New Richmond Bridge – Stage 2 - REF

Thank you for the opportunity to provide feedback on the New Richmond Bridge -Stage 2 REF (*The Plan*).^[1] These comments have been prepared on behalf of CAMWEST, a Bicycle NSW affiliated Bicycle User Group (BUG) with a focus on advocating for and encouraging cycling in Western Sydney.

Mark-up of part of Figure 4-4,^[4] showing proposed shared crossing

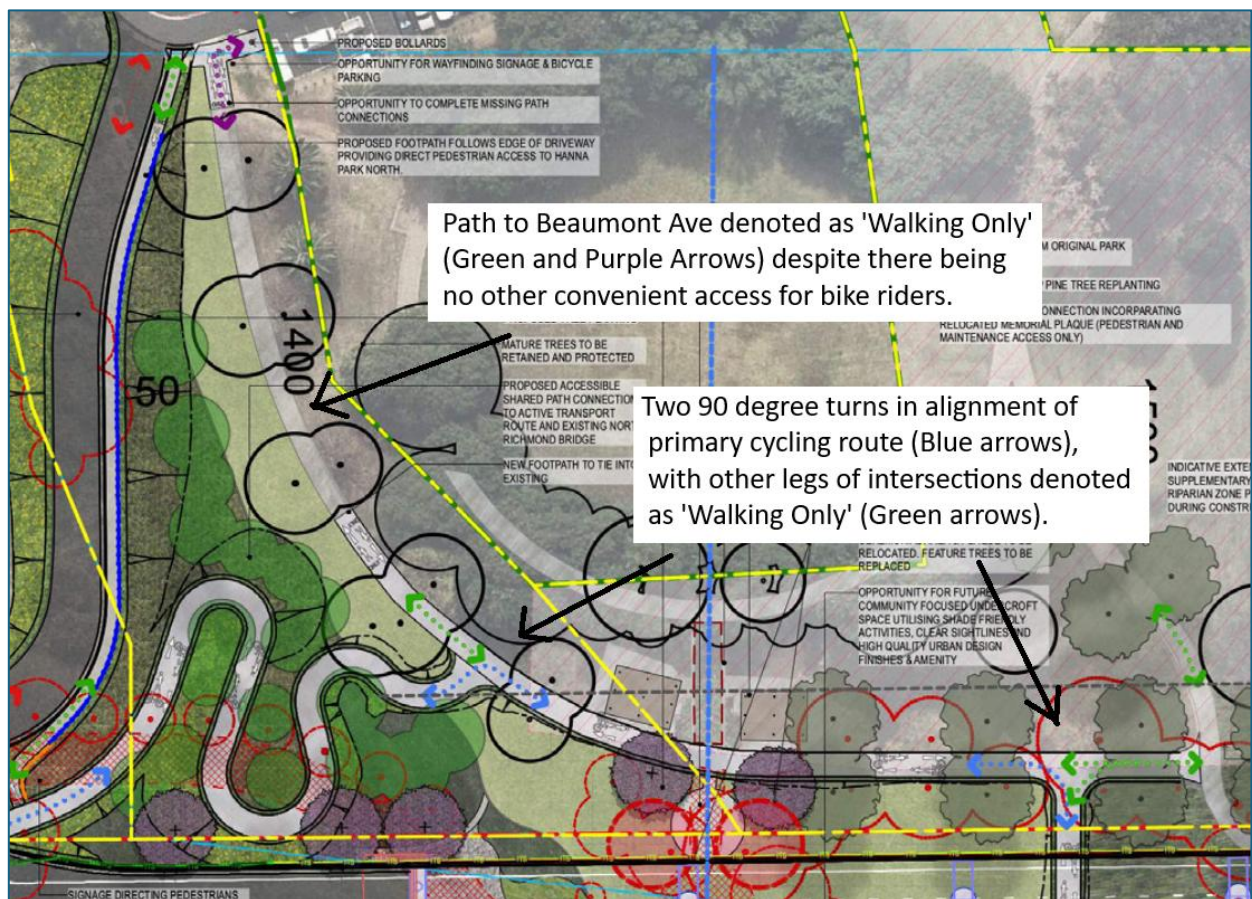
1. While noting that the 'Cyclist Dismount' signage at this exit from Westrock on the previous set of diagrams have been removed (or at least aren't present), CAMWEST would like to see a raised pedestrian and cyclist crossing installed here to give priority to Active Transport users.

Mark-up of part of Figure 4-5.^[4]

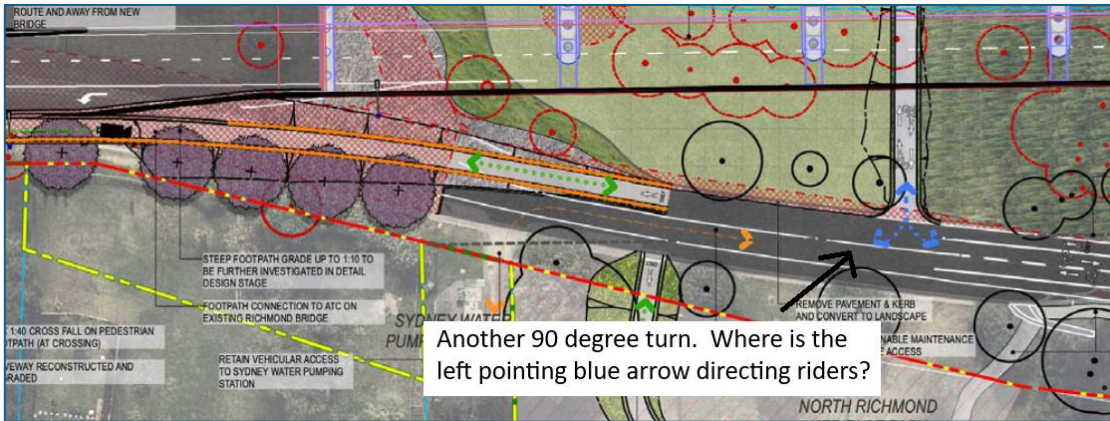
2. As shown in the mark-up of Figure 4-5 above, there are two 90 degree turns in this section of the primary cycling route, with the other legs of these intersections denoted as for pedestrians only (despite current maps defining at least some as SUPs). 90 degree turns make the primary route less obvious and increase the risk of startling pedestrians with riders suddenly rounding corners. Where possible, CAMWEST believes the primary route should have the least number of turns possible.

3. The linking path between the primary route and Beaumont Ave/Hanna Park car park is denoted as a pedestrian-only path. The existing section of this path appears to be around 2.5m wide and is currently used as part of the Bells Line of Road to Bridge detour (as captured on the Open Street Map images in this document). Going forward, if this is for pedestrians only, what is the plan for bike riders travelling to/from Panthers North Richmond, or those in residential properties around Beaumont Ave & surrounding streets to access the bridge SUP? There is the new access road which appears to be to the Westrock carpark and may be usable if un-gated, but this requires riders travelling between the bridge and Beaumont Ave to ascend the hill then immediately descend it again. From our perspective the most logical solution is to have this section of pathway declared as a SUP.

4. Another 90-degree turn in the main SUP alignment. Where is the left-pointing blue arrow directing riders? I can see two paths branching off, but they have green arrows for pedestrians only. Is this for riders who have ridden from Richmond across the new bridge to do a sharp turn and pass under the new bridge to the other side of Bells Line of Rd?

Mark-up of part of Figure 4-6.^[4]

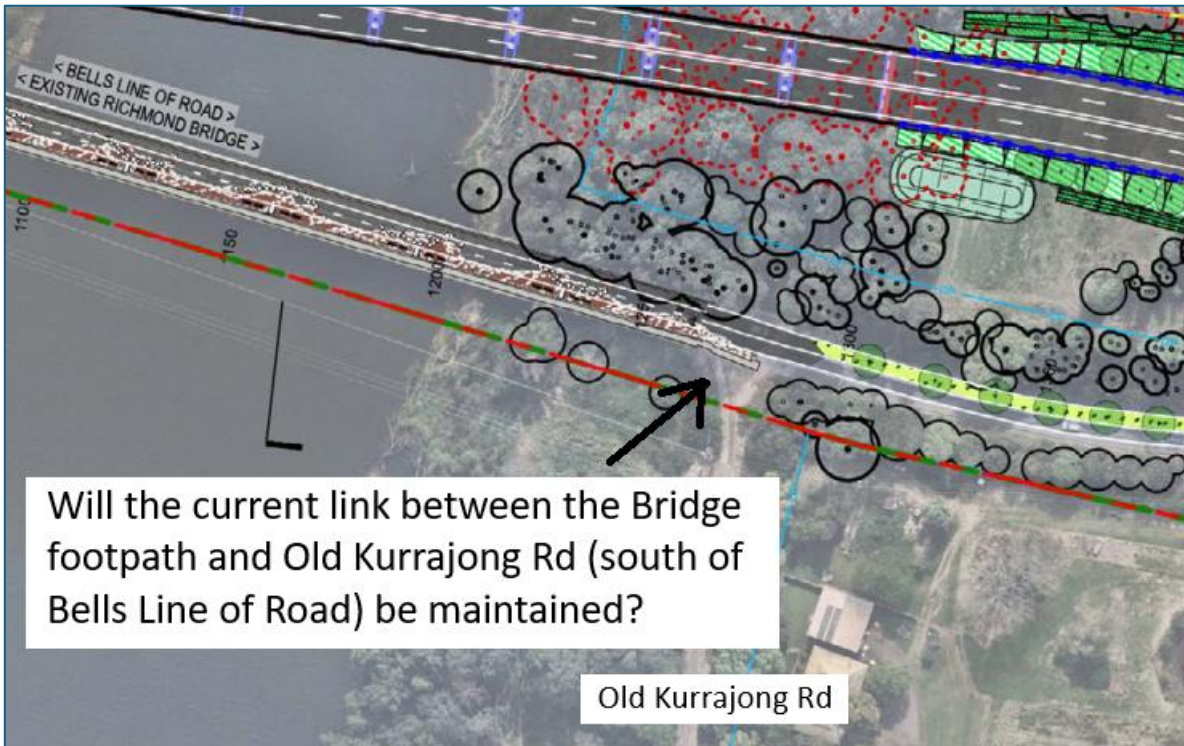
5. There's currently a pedestrian footpath leading from the path under the existing bridge to Shortland Close (indicated by the arrows on the map). Although not officially part of the Hawkesbury Active Transport Plan and largely outside the scope of this project, we would like to see the design elements within scope at the bridge end of the route to be amended from pedestrian only to shared path. This could pave the way for the complete section to become a shared path in the future.

6. There is no indication on Figure 4-6 that the existing footpath link on the eastern side of the river to Old Kurrajong Rd will be maintained. If it is maintained, will the barrier alongside the roadway be removed so that riders (on what is now the roadway) will be able to access the pathway? Are there plans to widen this short section of pathway?

Mark-up of part of Figure 4-7^[4]

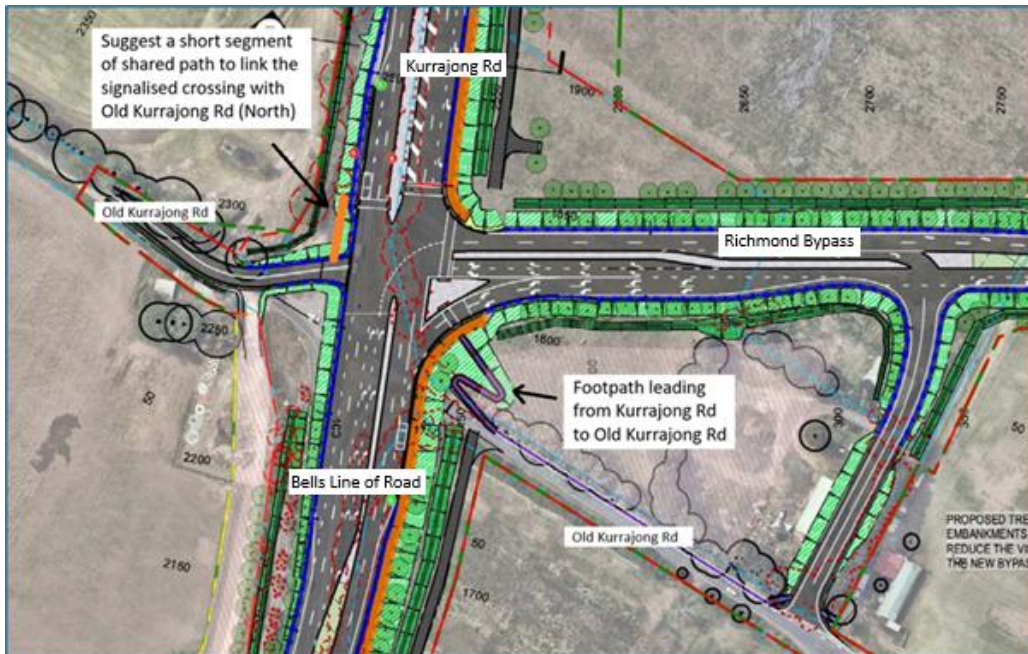
7. We note that the connection between the Bells Line of Road/Kurradjong Rd/Richmond Bypass route intersection and Old Kurradjong Rd (South) is a pedestrian footpath. Our preference would be to have this as a shared path, although if the link in point 6 above is to remain then that would reduce the inconvenience for some riders.

8. As noted above, Old Kurradjong Rd north of the above intersection is a popular cycling route. We note in the documentation that the current plan is to have a normally closed gate across this section of Old Kurradjong Rd, blocking vehicular access to/from the intersection. We would like to see bike riders and pedestrians be able to access Old Kurradjong Rd (North), and a short section of shared path installed between the Kurradjong Rd signalised crossing and Old Kurradjong Rd (north) as indicated in the diagram.

Mark-up of part of Figure 4-8.^[4]

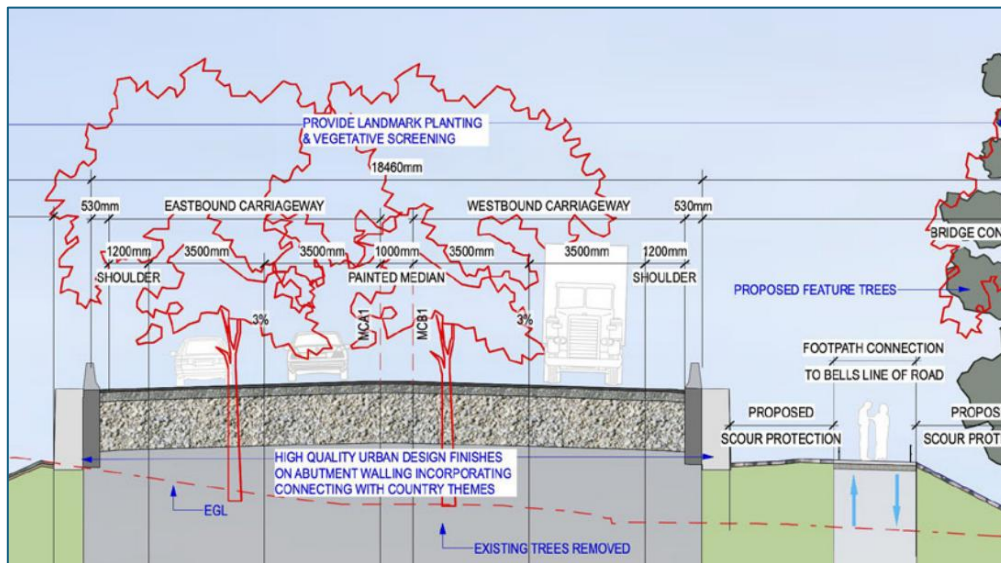
9. We question the design of the refuge island in the centre of Kurradjong Rd, west of Chapel St. Is the width of the island wide enough to fit a standard bike comfortably? What about longer bikes (eg Cargo bikes/tandems) or trikes? If riding in a small group, how many riders could fit side-by-side in the refuge? Would an offset refuge be more appropriate in this case?

Part of Figure 4-12 ^[4] – New bridge

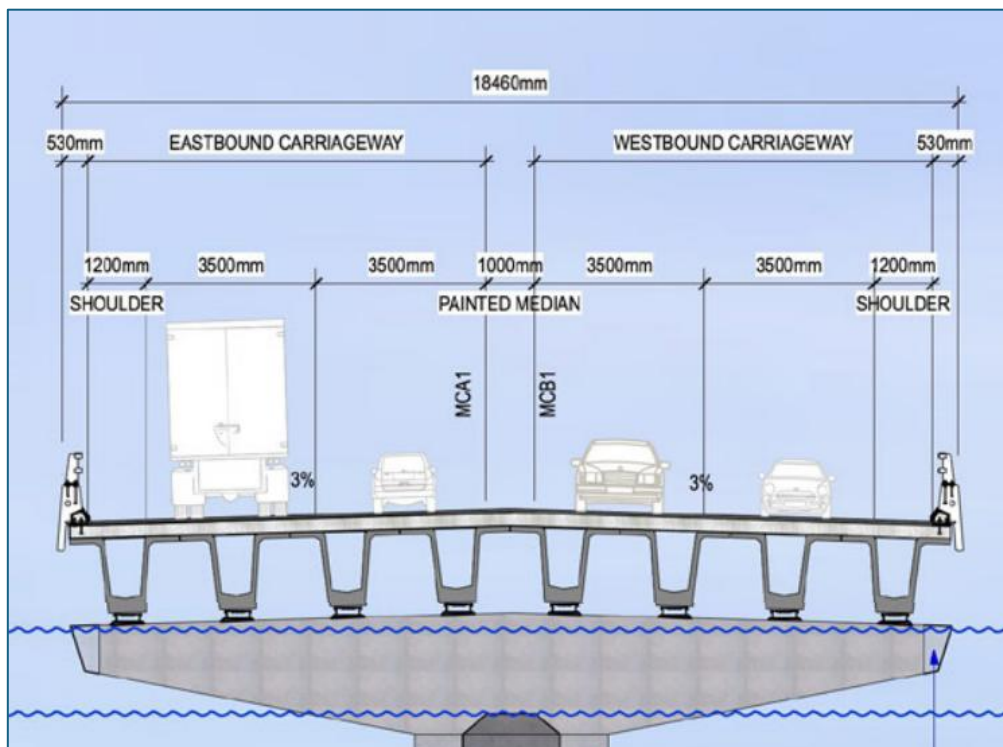
What are the plans for Active Transport users when the old bridge is closed due to flooding? While the number of users may be low during intense rainfall periods, rider numbers would likely increase after the worst of the rainfall has finished and before the water level subsides sufficiently to safely use the old bridge again.

There is no footpath or shared path on the plans for the new bridge – just a 1.2m wide shoulder on each side. Will riders be expected to use this shoulder? While 1.2m may be adequate for confident on-road riders in a 60 kmph zone traversing a relatively flat area, is it adequate to compensate for the ‘wobble’ that many riders experience when riding up inclines (in this case the approaches to the bridge)? Have provisions been made for riders to safely enter and exit the roadway shoulder either side of the bridge? What about pedestrians who may want to view the flooding from the bridge, or those riders who want to cross the bridge but feel unsafe about riding on the roadway so close to vehicular traffic? Is this in alignment with TfNSW Active Transport policy?
